# CITY OF ALBUQUERQUE

Re: Ameristone Assisted Living
7503 Central Ave. NE
Traffic Circulation Layout
Engineer's Stamp 11-13-17 (K19D150)

Based upon the information provided in your submittal received 11-27-17, the above referenced plan cannot be approved for Building Permit until the following comments are addressed:

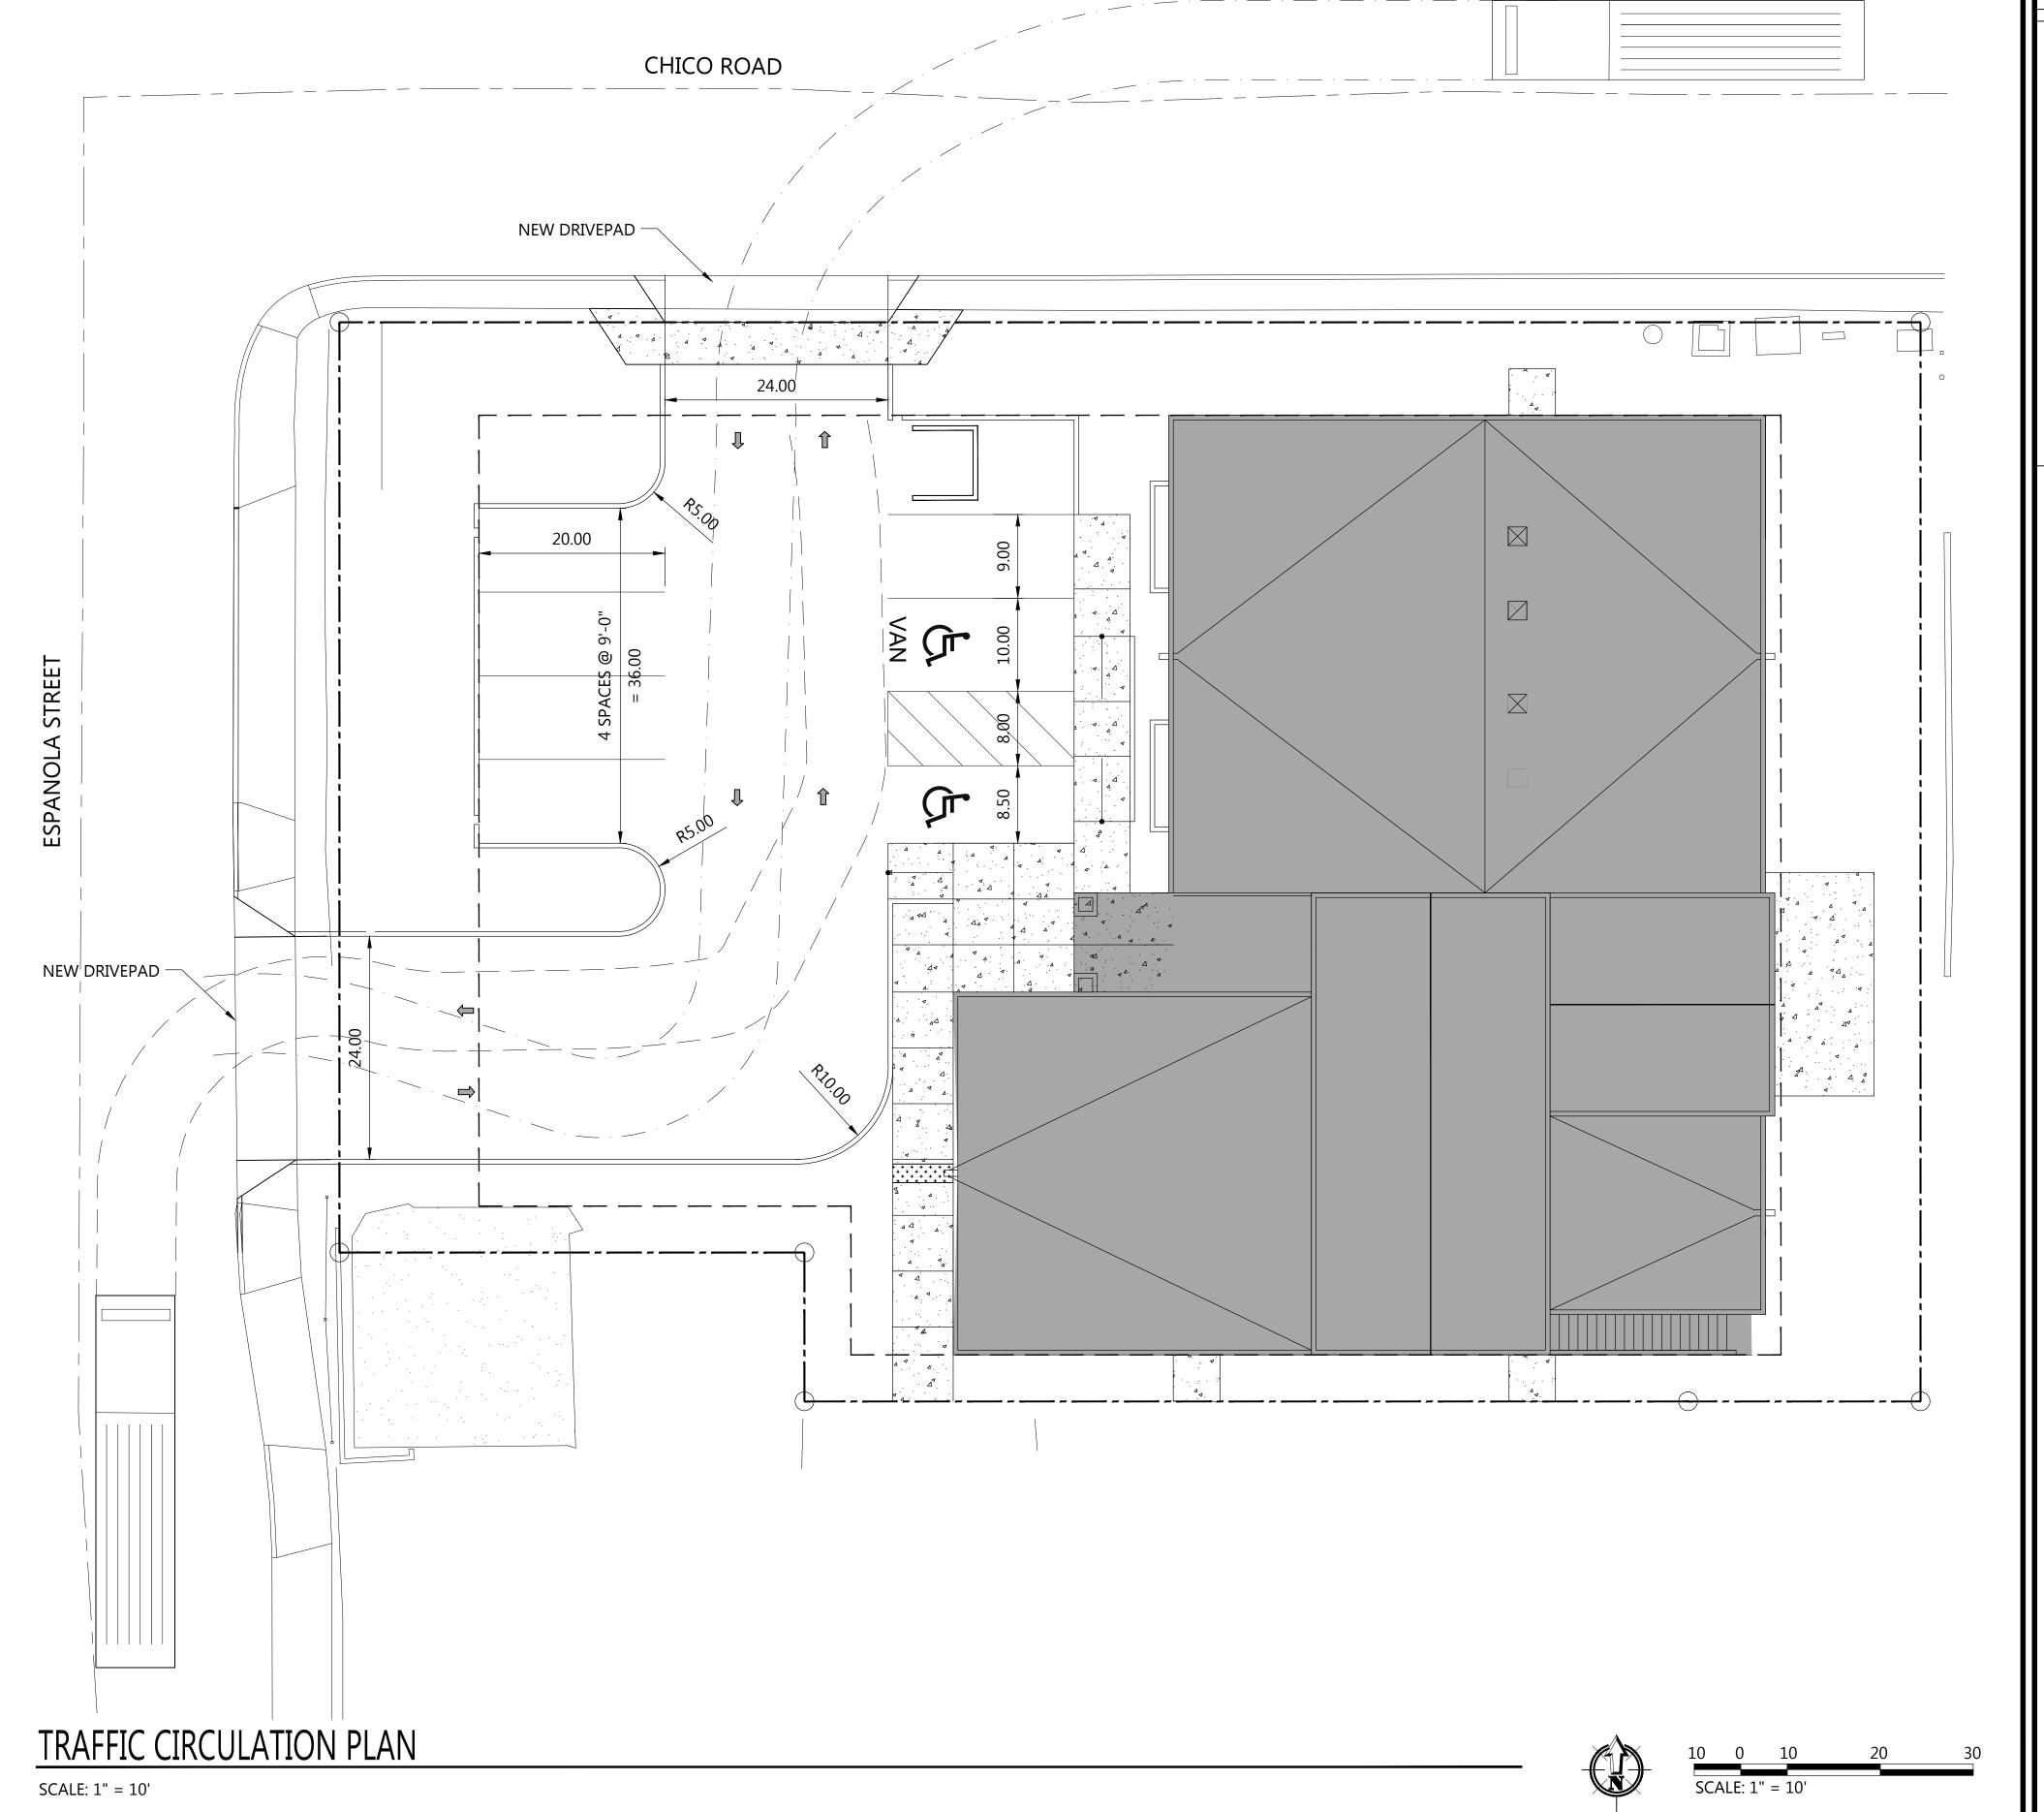
- 1. List the number of parking spaces required by the zoning code as well as the proposed number of parking spaces including bicycle and motorcycle parking.

- Identify the right of way width, sidewalk, curb cuts, and street widths on Espanola St. NE and Chico Rd. NE.
- The ADA accessible parking sign must have the required language per 66-7-352.4C NMSA 1978 "Violators Are Subject to a Fine and/or Towing." Please call out detail and location of HC signs.

- 4. The ADA access aisles shall have the words "NO PARKING" in capital letters, each of which shall be at least one foot high and at least two inches wide, placed at the rear of the parking space so as to be close to where an adjacent vehicle's rear tire would be placed. (66-1-4.1.B NMSA 1978)

- 5. Motorcycle parking spaces shall be designated by its own conspicuously posted upright sign, either free-standing or wall mounted per the zoning code.

- 6. Per the zoning code, a 6 ft. wide ADA accessible pedestrian pathway is required from the public sidewalk to the building entrances. Please clearly show this pathway and provide details.

- Per DPM, a 6 ft. wide ADA accessible pedestrian pathway is required from the HC parking stall access aisles to the building entrances. Please clearly show this pathway and provide details.

- 8. Please list the width and length for all existing and proposed parking spaces. Some dimensions are not shown.
- All ADA accessible ramps in COA ROW shall have detectible warning surface that meet COA standards.

- 10. Provide a min 6" or max 8" high concrete barrier curb or other acceptable barrier between landscaping and parking areas and/or drive aisles. Please call out detail and location of barrier curb. Curbs are not called out on the plan.

- 11. It is not apparent what type of pavement surface is being proposed. A hard driving surface will be required as part of this proposed project for parking area and drive aisles.

- 12. Show the clear sight triangle and add the following note to the plan: "Landscaping and signage will not interfere with clear sight requirements. Therefore, signs, walls, trees, and shrubbery between 3 and 8 feet tall (as measured from the gutter pan) will not be acceptable in the clear sight triangle.

- 13. Service vehicle and/or refuse vehicle maneuvering must be contained on-site; provide a copy of refuse approval.
- 14. Unused curb cuts must be replaced with sidewalk and curb & gutter. A build note must be provided referring to the appropriate City Standard drawing.
